Issues brought up by P802.1ag Draft 6

Norman Finn

Rev. 1

Problem 1

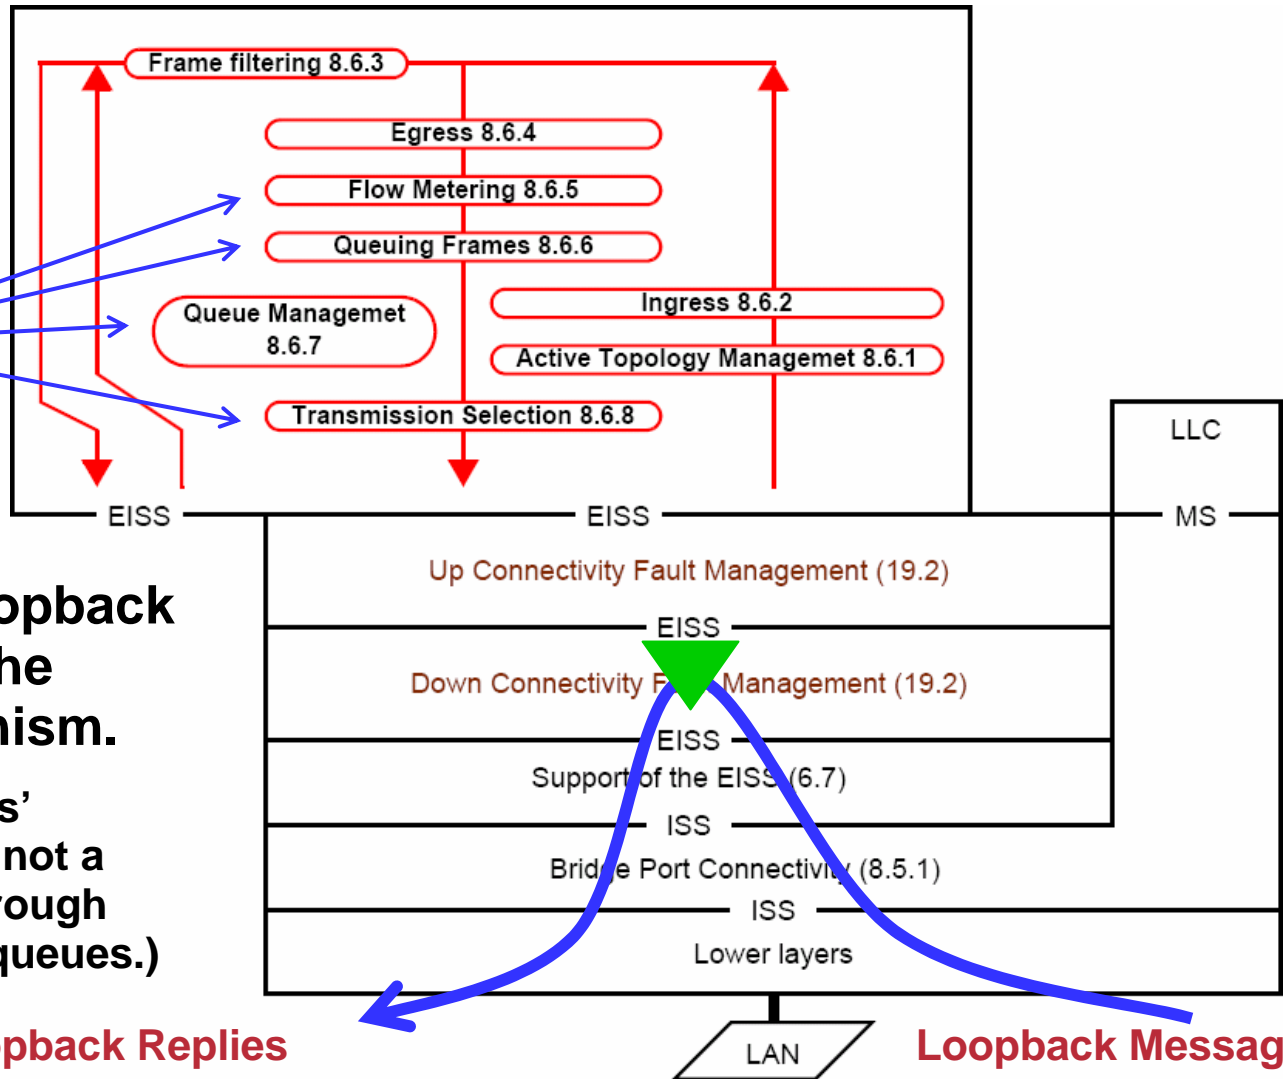
- Down MEPs' Loopback path **bypasses** the queuing mechanism.
- (This Port's Up MEPs' Loopback paths are not a problem; they go through other Ports' output queues.)

Problem 2

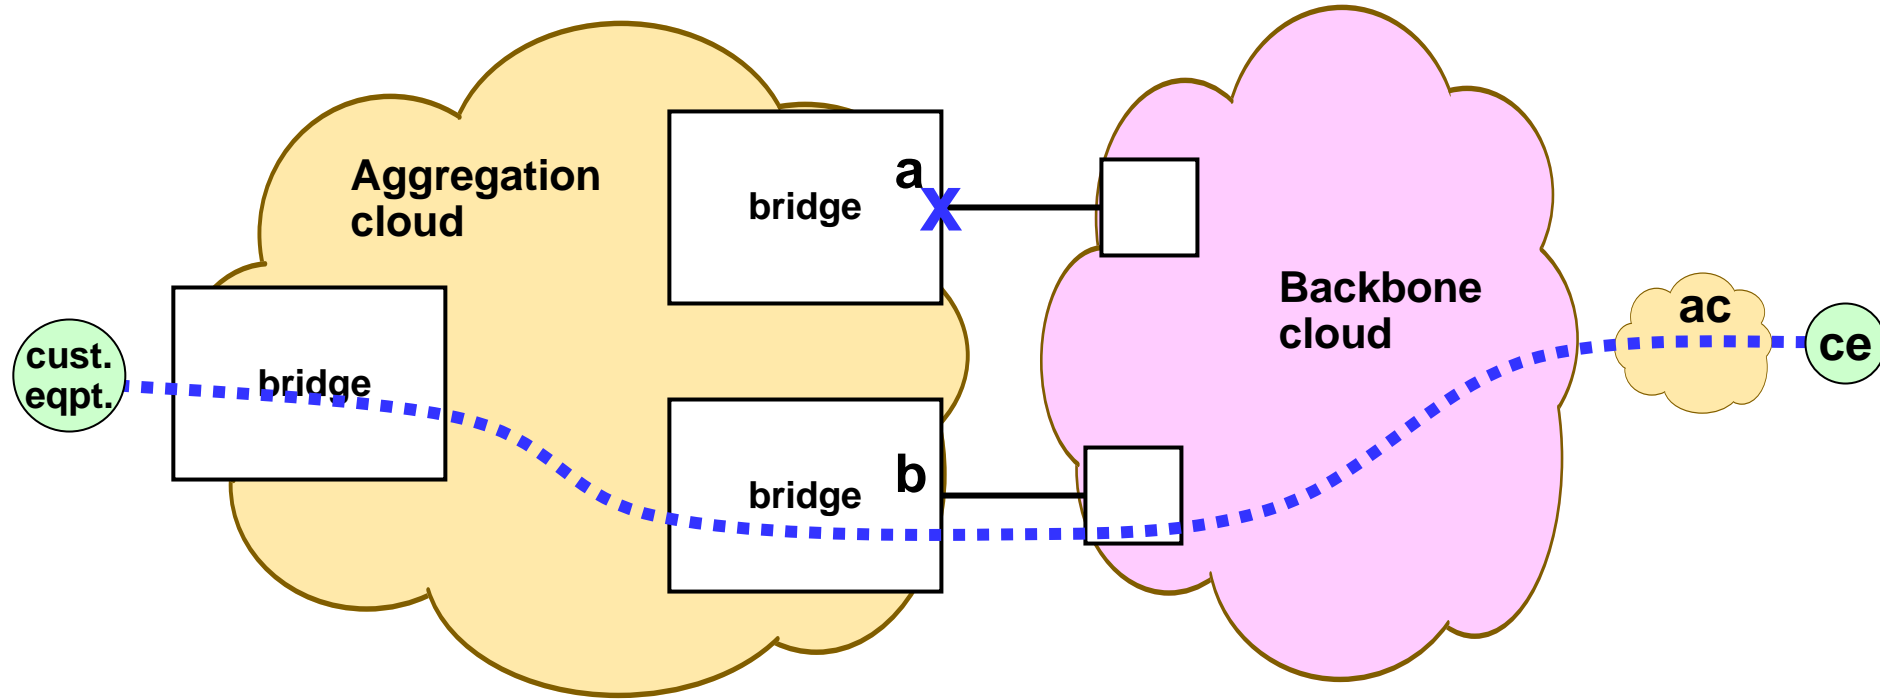
- Point to point service (MA in blue).
- Access cloud selects the bridge, a or b, to use for this service. Blue X marks the blocked port.

Problem 2

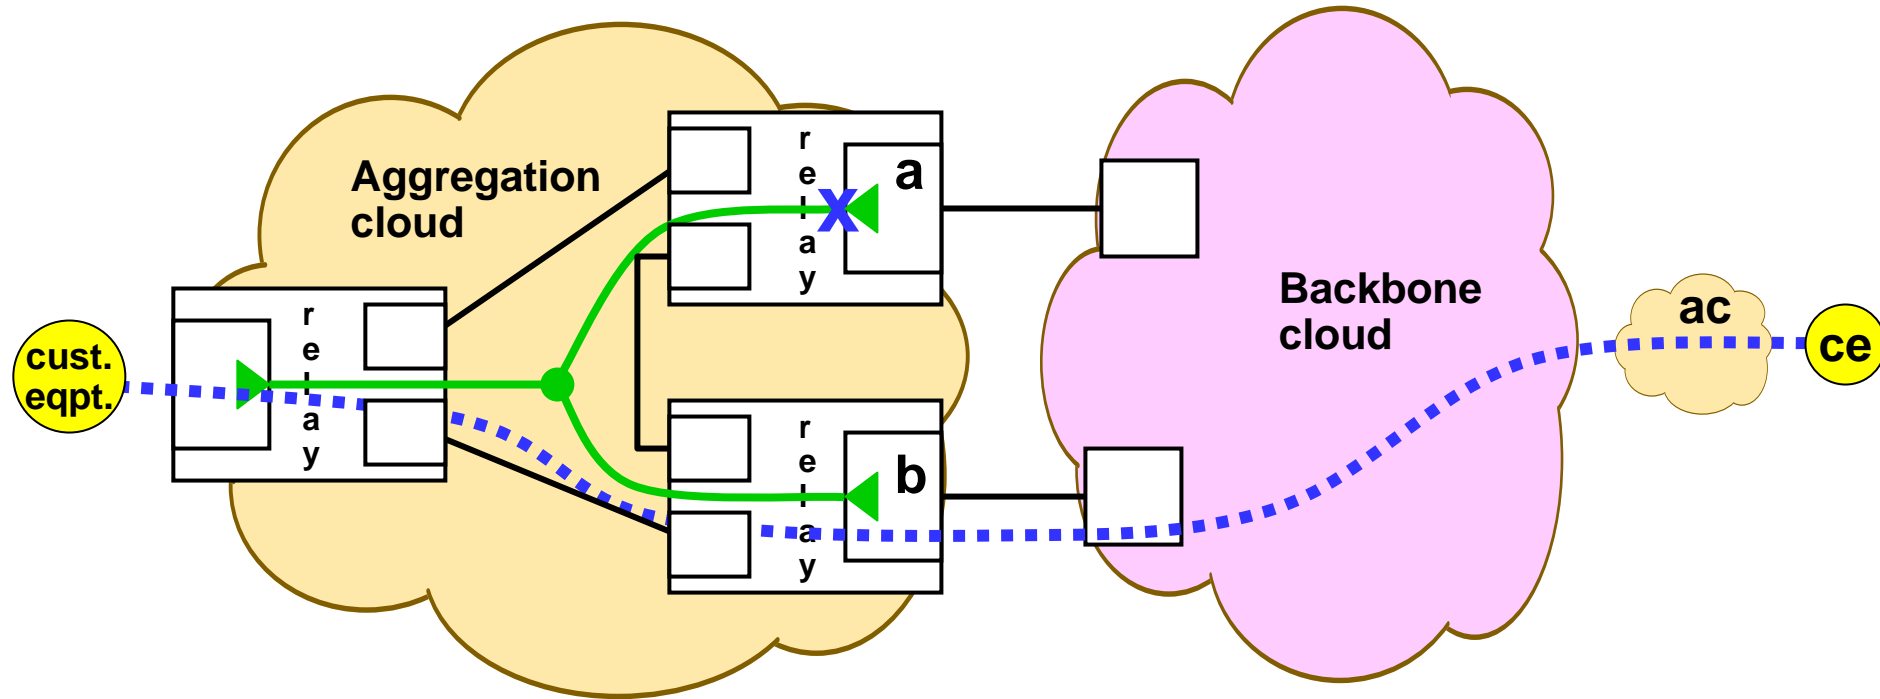
- Aggregation cloud operator creates a 3-point (**green**) service to support the 2-point (**blue**) service.
- Block (blue **X**) is in Relay, not outside the Port.
- How does Agg. cloud operator know whether Port a, or the Bridge it belongs to, are working?

Problem 2

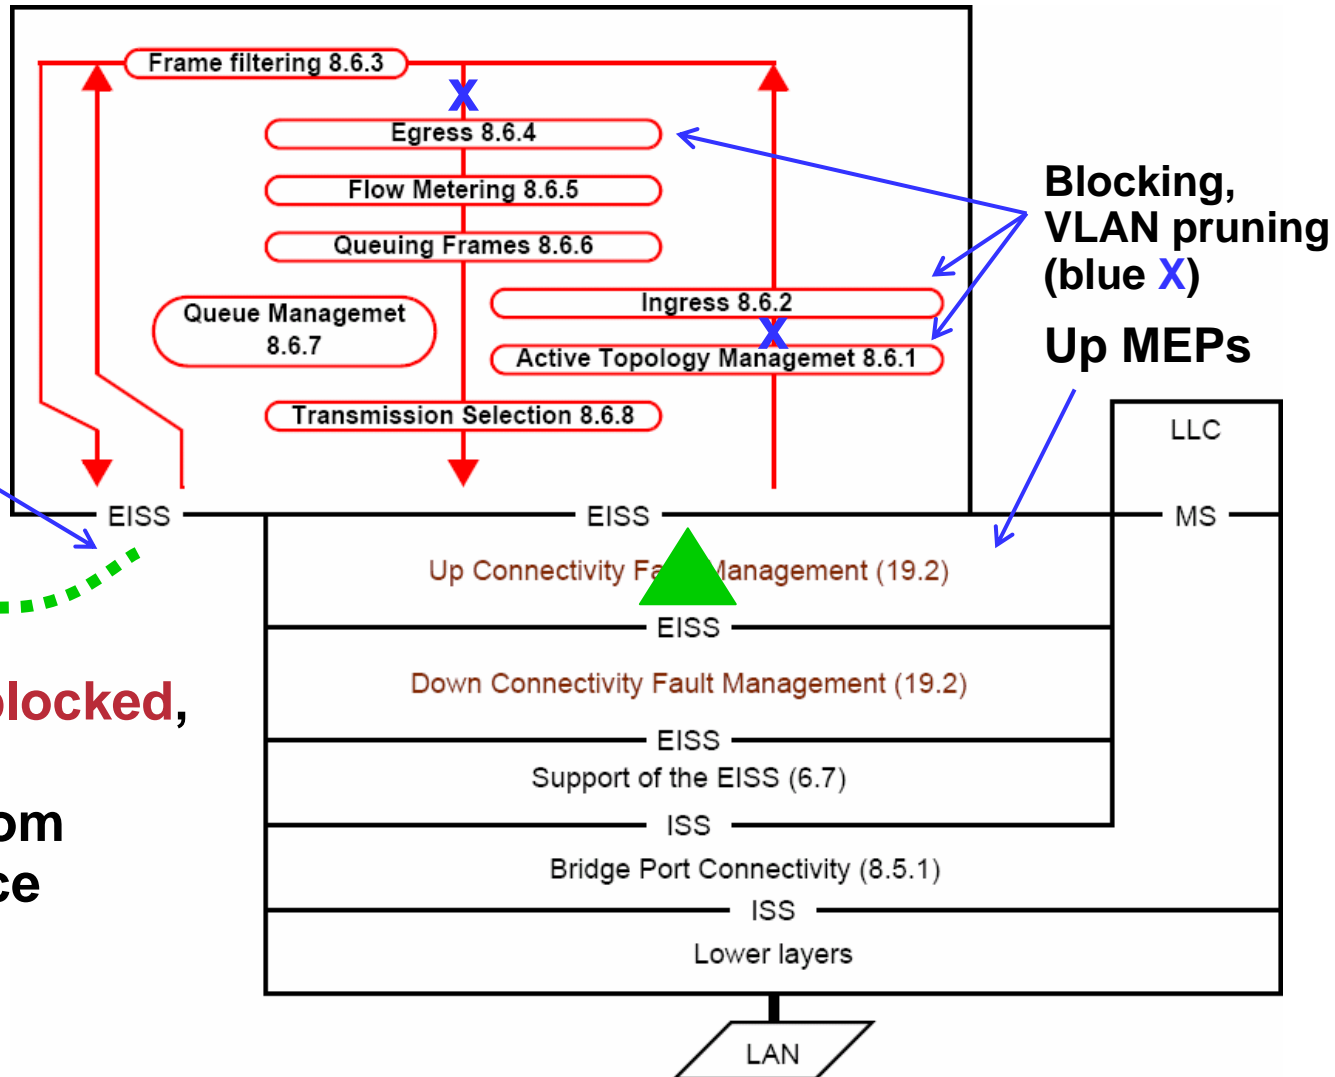
1. When a Port is **blocked**, Up MEPs are **disconnected** from their Maintenance Associations.

The Proposed Solution: Step 1

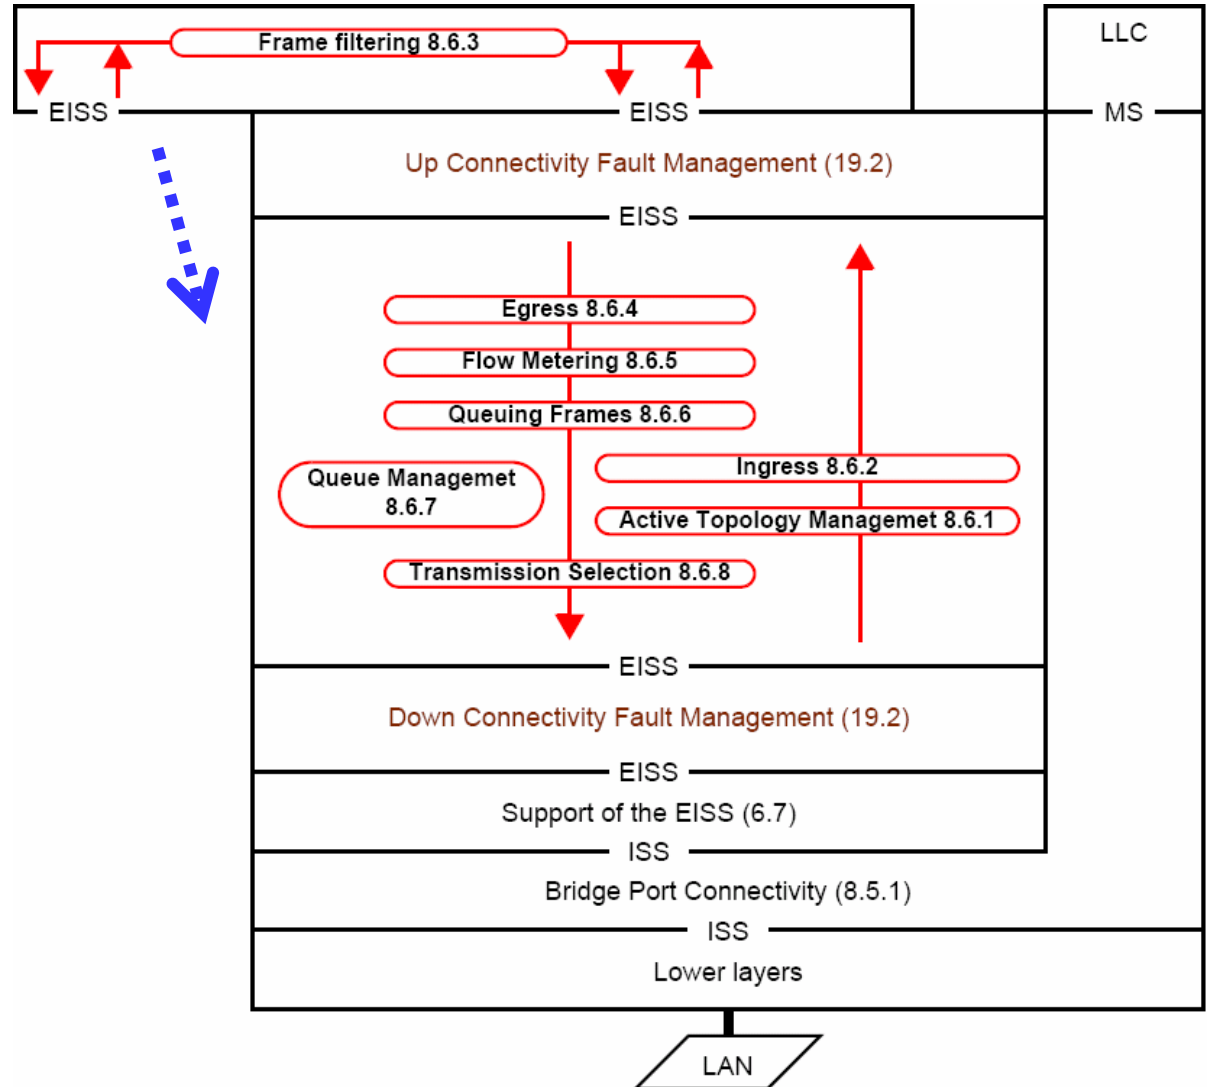
- **Move** per-port parts of the Forwarding Process down into the Bridge Port.
- This is a **technical change** from P802.1ag Draft 6.0.

The Proposed Solution: Step 2

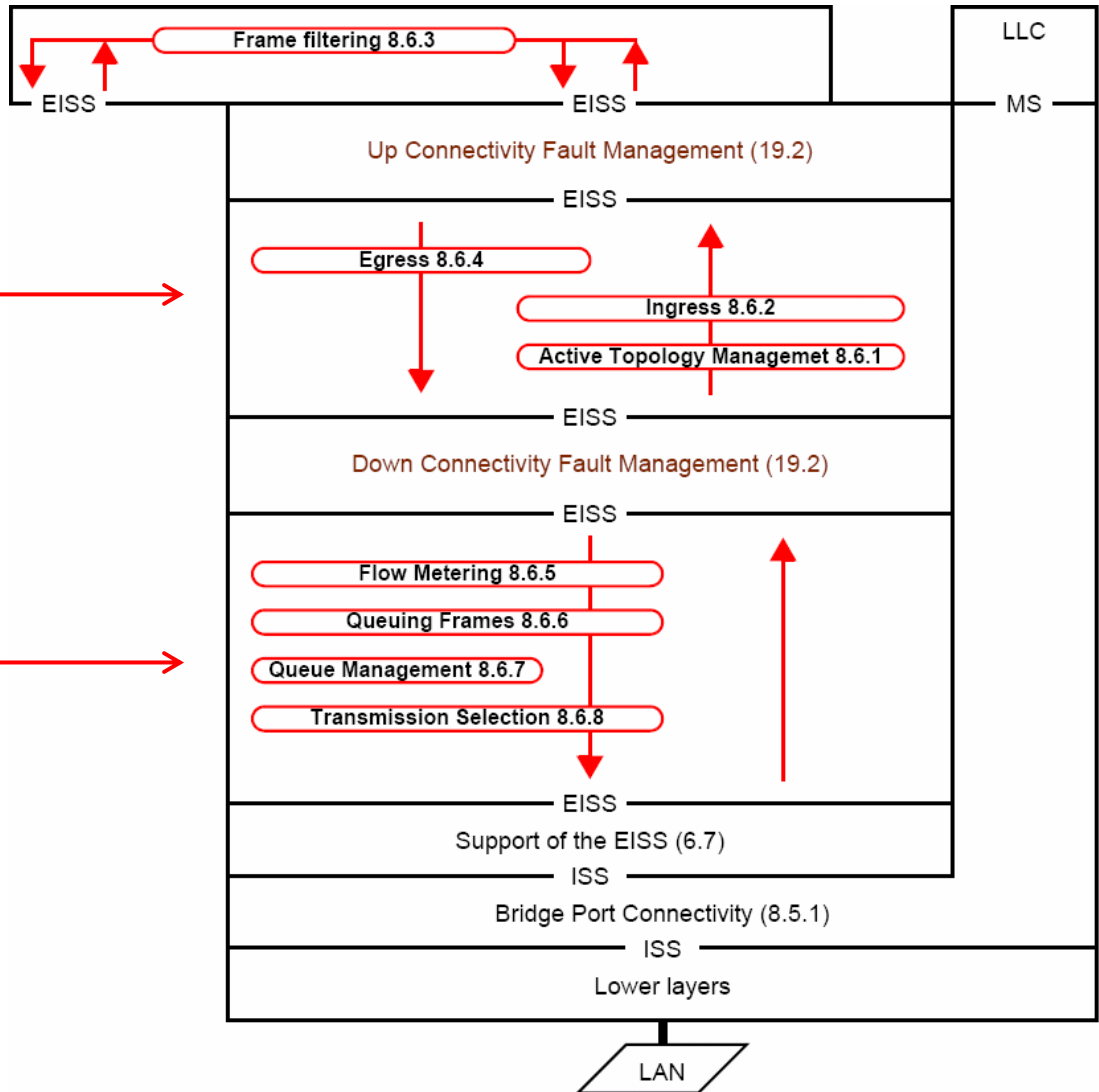
- **Separate** Queuing from ingress/egress filtering.

- **Move** Queuing down even further.

Where is the DSAP? The ISAP?

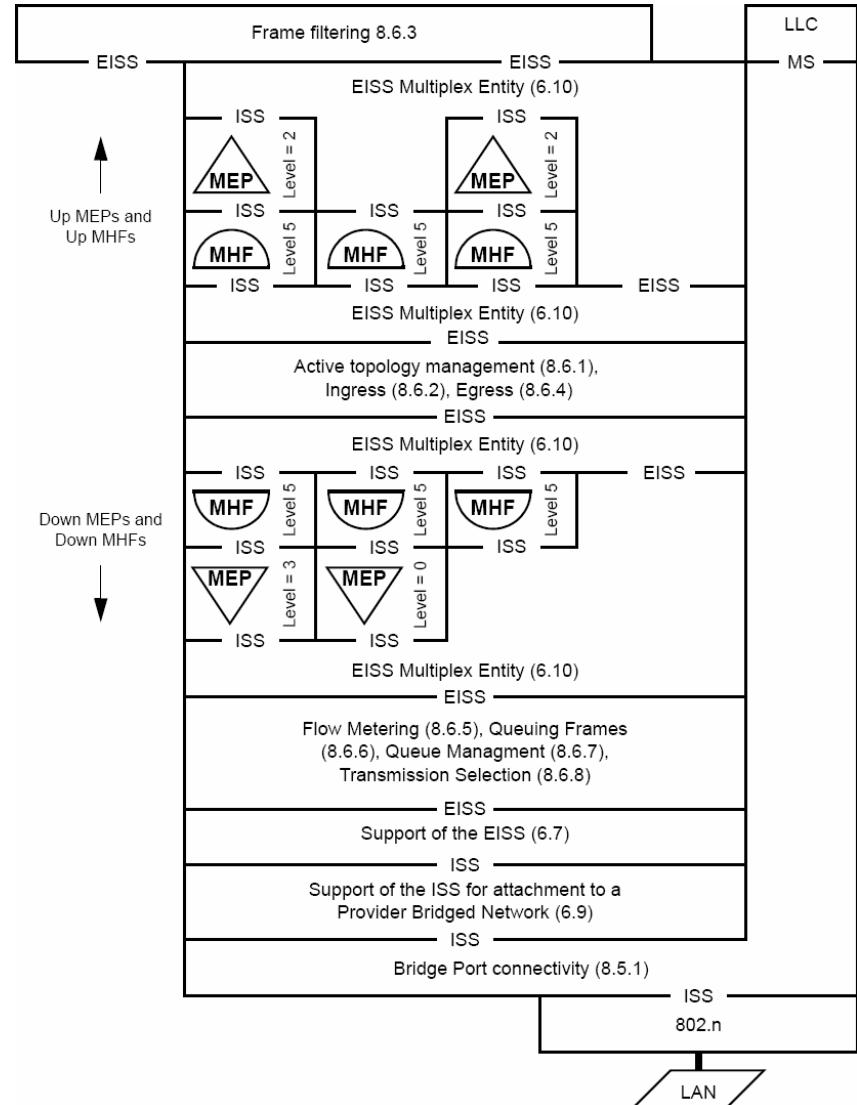
- **Draft 6.0 attaches the DSAP to the MEP, and the ISAP to the MIP.**
- **Clause 18(.0) indicates that:**
 - The DSAP belongs to a Maintenance Domain.**
 - That DSAP can be assigned to a Service Instance.**
 - That Service Instance can be protected by a Maintenance Association (MA).**
 - A MEP belongs to the MA.**
- **If the DSAP exists before the MEP exists, it cannot be defined by the MEP.**

Where is the DSAP? The ISAP?

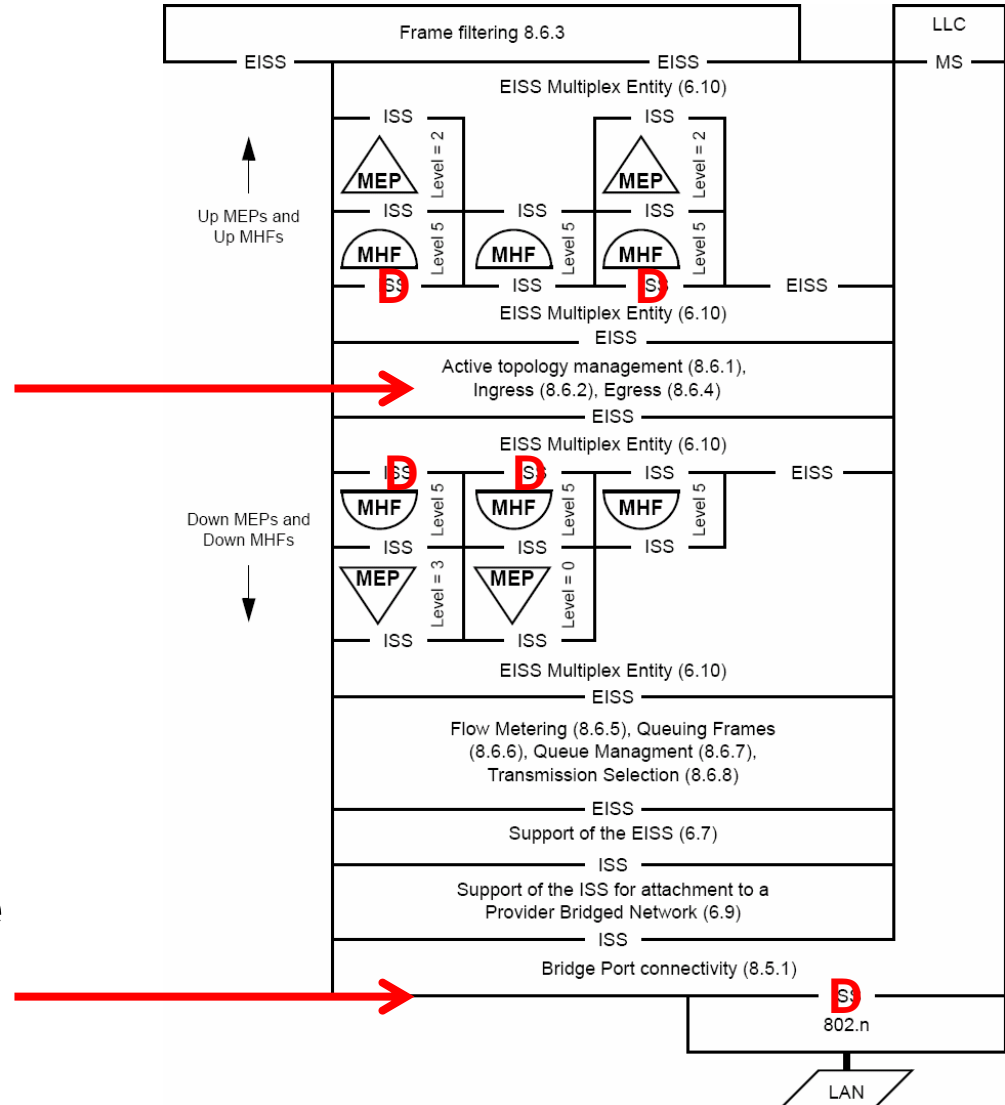
- This is where the per-VLAN pass/don't pass decisions are made, so it seems DSAPs should be here, or adjacent to here.
- When the Service Instance is the whole LAN, this is the appropriate place.
